Surfrider Foundation
Ventura County Chapter – Matilija Coalition
PO Box 1028 Ventura, CA 93002
(805) 667-2222 www.matilija-coalition.org

October 24, 2008

Comments on Matilija Dam Final Design – Levees:

Figure 2: Flooding analysis from 2007 Hydrology Study

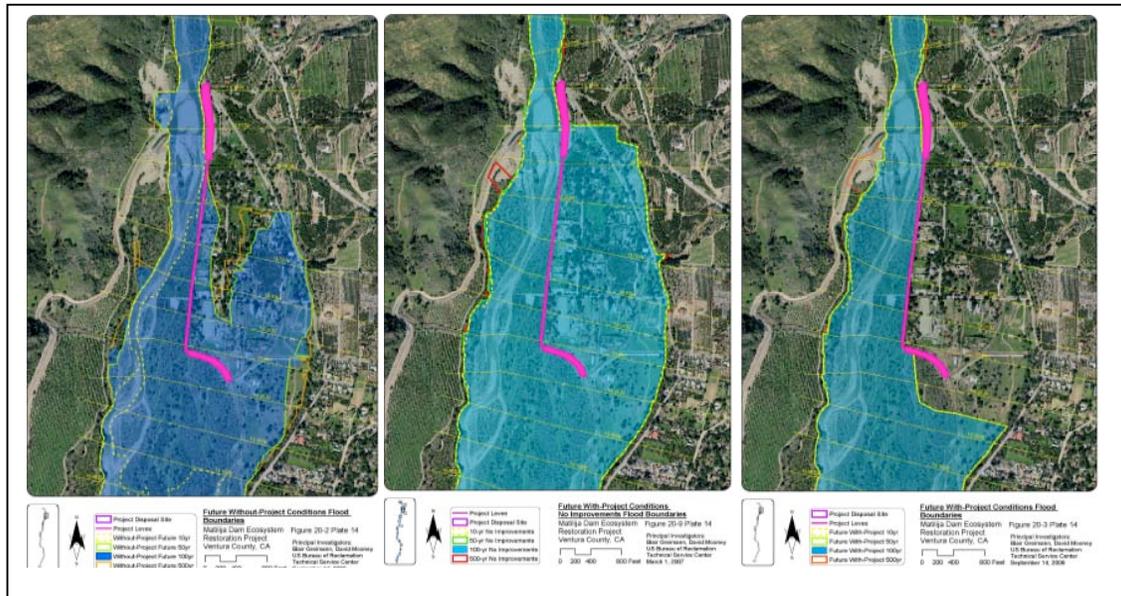
Meiners Oaks Levee Design: The attached figures show the analysis results for existing 100-year flooding threat, future flooding with dam removal, and intended flood mitigation with the proposed levee. The with-project flood predictions are absolute worst-case scenario: the 100-yr flood occurs immediately after dam removal. Inflow from upland tributaries was not included in these analyses. It is noted that the most recent analysis predicts a higher flood potential (both with- and without-project) than the Feasibility Study analysis. The analysis shows an incremental increase in flooding with dam removal in the worst-case scenario.

What changed in the more recent models? How does this analysis compare with the existing FEMA flood map? How does the flood risk change over time following dam removal?

Figure 3. Map of Features near Live Oak levee.

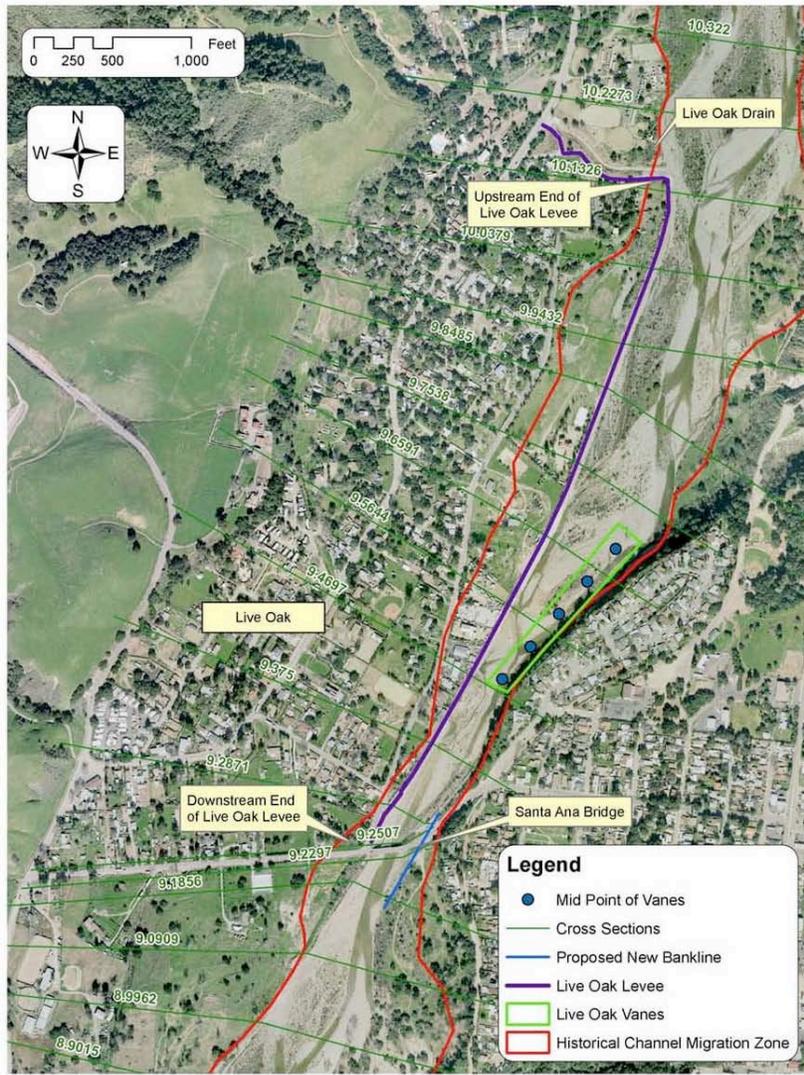
The Live Oak Levee constricts the floodplain in a critical area and is in poor repair. Plans call for complete reconstruction with a larger levee system, which may present an opportunity to enhance the ecosystem objectives of the project. For instance:

- Are there set-back alternatives that may increase the floodplain area upstream of the bridge in order to attenuate peak flows?
- Can flowage easements be purchased like the Camino Cielo neighborhood?
